Figure 3.22: Baseline Surface Water flows at Stream locations north-east of the site

Surface Water Flow Rate - SW8 / STR2

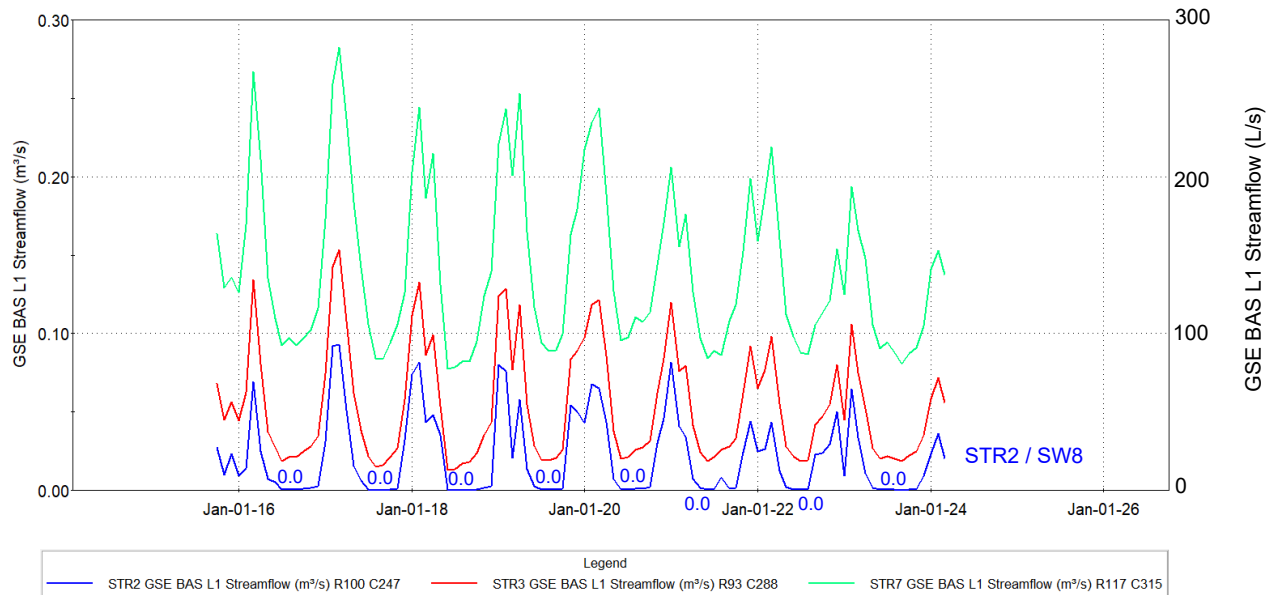
- 1) Genivar (2011) Table H-27 reported simulated Groundwater Discharge Rate at SW8/STR2 at 3,520 m³/day (40.7 L/s) and calculated observed low baseflow at 3,575 m³/day (41.4 L/s).
- 2) Newell / Funston Commercial Aquaculture (Fish Hatchery / Rearing Ponds) MECP Permit PTTW #7121-9Y7HP7 total is 741 m³/day (8.6 L/s) (Earthfx Aug 2024, pg D-102) immediately downstream of SW8/STR2.
- 3) Genivar DP-SW8 reported Mean Flow at 0.35 m³/sec (350 L/s) in Earthfx Aug 2024 Table 3.6, pg D-57 and Table 4.3, pg C-83 or in the source material. This flow is an obvious error.
- 4) Earthfx (August 2024) Fig 3.22 pg 37 Simulated Virtual Model Baseline Condition Dry Weather Flow at SW8/STR2 is at 0.0 L/s.

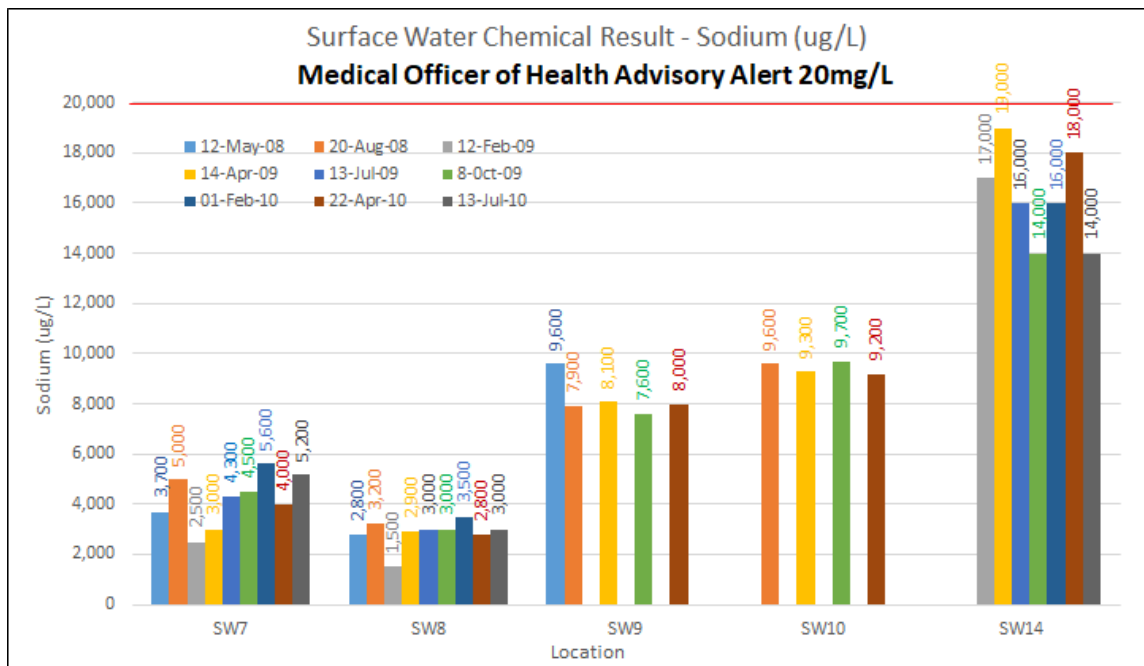
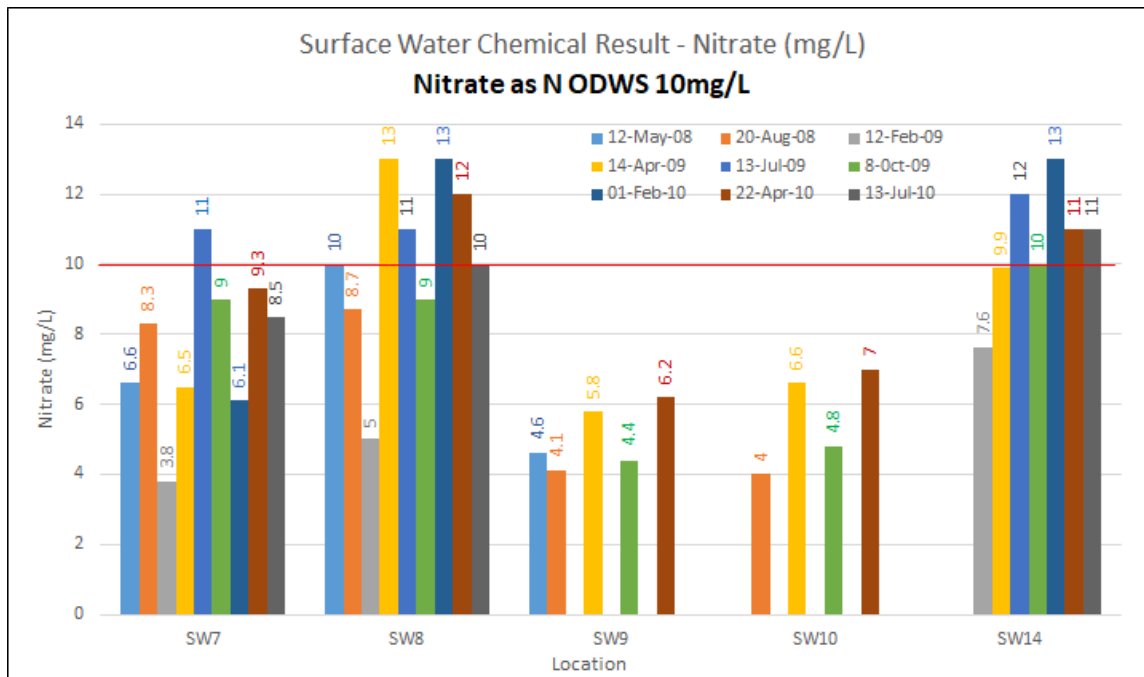
The Earthfx Model Calibration for Baseline Conditions is obviously not validated for assessment prediction purposes.
